MEMORANDUM

FILE NO.: VAR2011-0013

PROPOSAL: Variance request to reduce the side yard setback from 5' to 3' for an addition.

Property Address: 419 West Twelfth Street

AS-BUILT SURVEY OF

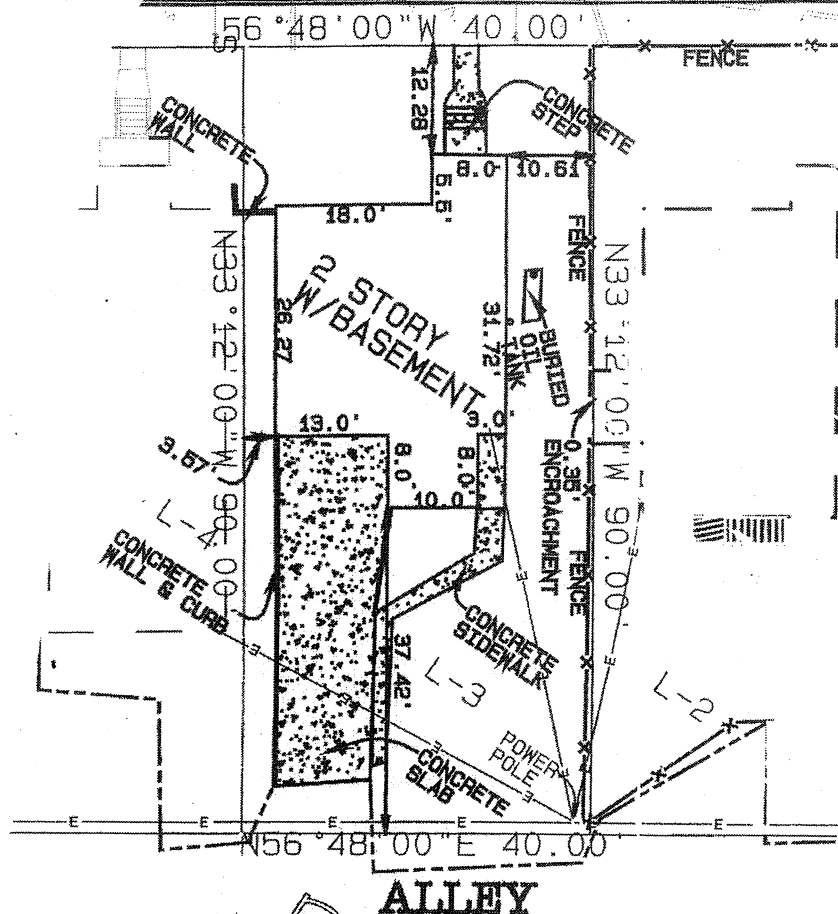
There is one other item I need to mention. The as built does not meet any survey standards of practice. Just to mention a few items: No Basis of Bearing or controlling monuments. A complete as built that meets survey standards is required.
